S E R V I C E N O T E

E1652A 75000 Series 90 Modular SONET/SDH Analyzer**Serial Numbers:**

Disabling of ECLTRIG1 Line on E1405A or E1405B Command Module due to incorrect pin connection on E1672A or E1674A Transport Overhead Module.

Figure 1

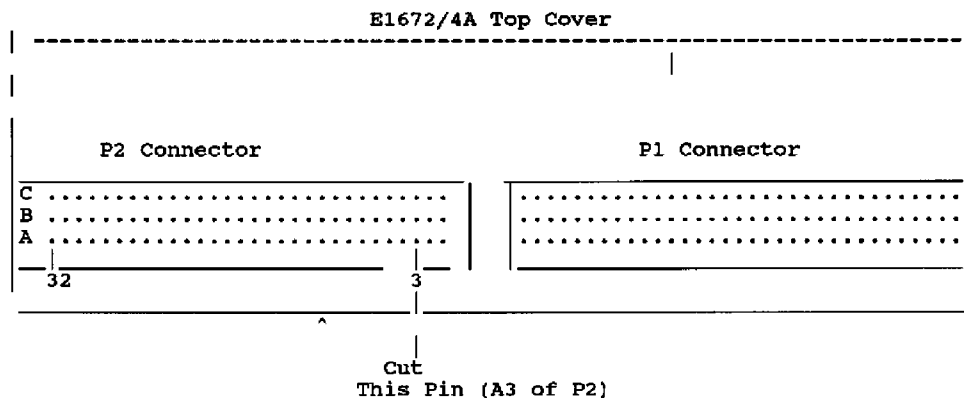
75000 Series 90 Modular Sonet/SDH Analyzers with Transport Overhead Modules with Serial numbers as shown above have a -5.2 volt supply incorrectly connected to pin A3 of the P2 connector of the E1672A and E1674A. This connects via the E1400B VXI Mainframe backplane, to the ECLTRG1 output of the E1405A/B. This causes the ECLTRG1 output to be rendered inoperative. This will not in any way affect the operation of the Series 90 but will affect any VXI modules which use the ECLTRG1 output and are used in the same mainframe as the Series 90.

Using the cutters recommended, clip pin A3 of the P2 connector on the E1672/4A module, off at the connector base so that it cannot make contact with the corresponding socket in the mainframe backplane. Be sure to capture the off cut of the pin to ensure that it cannot cause damage.

Refer to figure 1 below to locate the correct pin.

Cut pin A3 of P2 with due care. Be careful not to bend adjacent pins
